# New Durafix fixing

## All toilets including Durafix

The forging part of the fixing has been changed from 2-piece to 1-piece

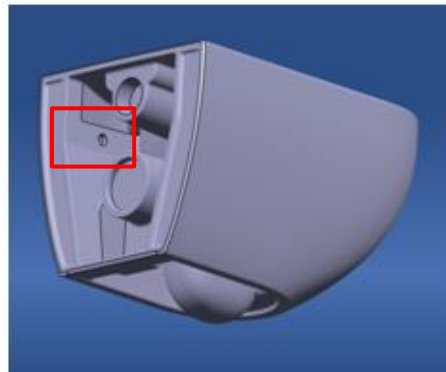
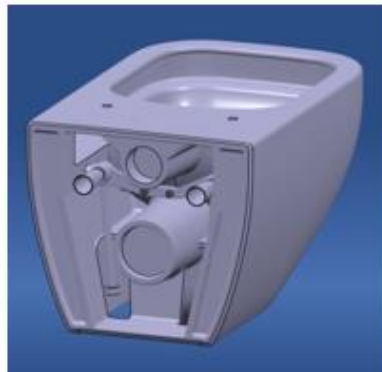
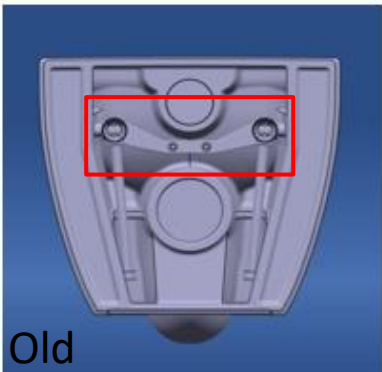
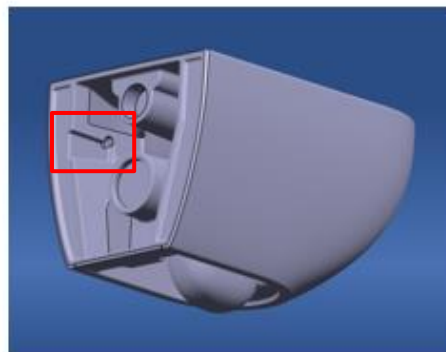
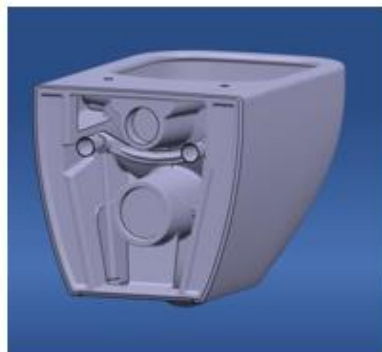
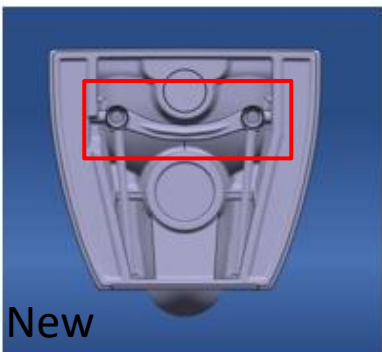
- ❑ Affected are all toilets with Durafix fixing 1003751000/1003761000
- ❑ Due to the new forging the ceramic needs to be adjusted. (marked in red)
- ❑ All affected toilets were versioned
- ❑ Spare parts 1003751000/1003761000 are no longer available

- ❑ 1009060000 forging 2-piece incl. springs/screws (old version)
- ❑ 1009120000 forging 1-piece incl. springs (new version)
- ❑ 1003771000 mounting set incl. screws 215mm, bolts, sleeves
- ❑ 1004551000 mounting set incl. screws 186mm, bolts, sleeves
